Service Information No. **SI 23 001 16R**

Transmission R models, K5x

BMW Motorrad has made technical updates to the transmission on the air- liquid-cooled boxer models. As with the R 1200 GS Adventure (K51), all air-liquid-cooled boxer models received a shock damper on the transmission output shaft as of July 2016. At the same time, a reworked control actuation, transmission shafts, as well as their bearings have been used. This results in a slightly longer installation length for the new transmission.

Figure 1: Visual inspection of gearshift cover (Transmission view from left bottom)

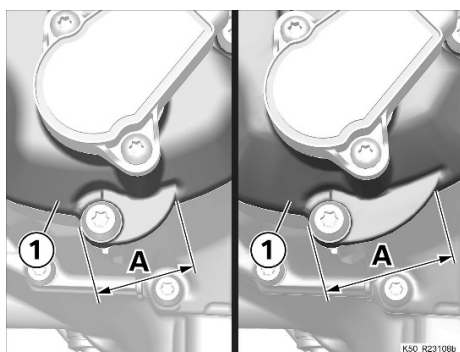
- Left image: Version from mid-July 2016 - dimension A approx. 30 mm
- Right image: Version until mid-July 2016 - dimension A approx. 45 mm

Figure 2: Serial number on countershaft

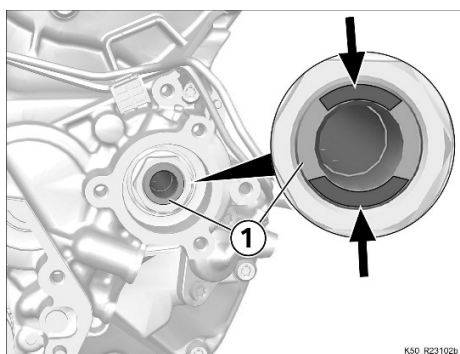
A precise identification of the transmission version is also possible by means of markings (serial number) (Arrow) on the countershaft (1).

- Version from mid-July 2016 – Ends with DMS
- Version until mid-July 2016 – Ends with MSI or BMS
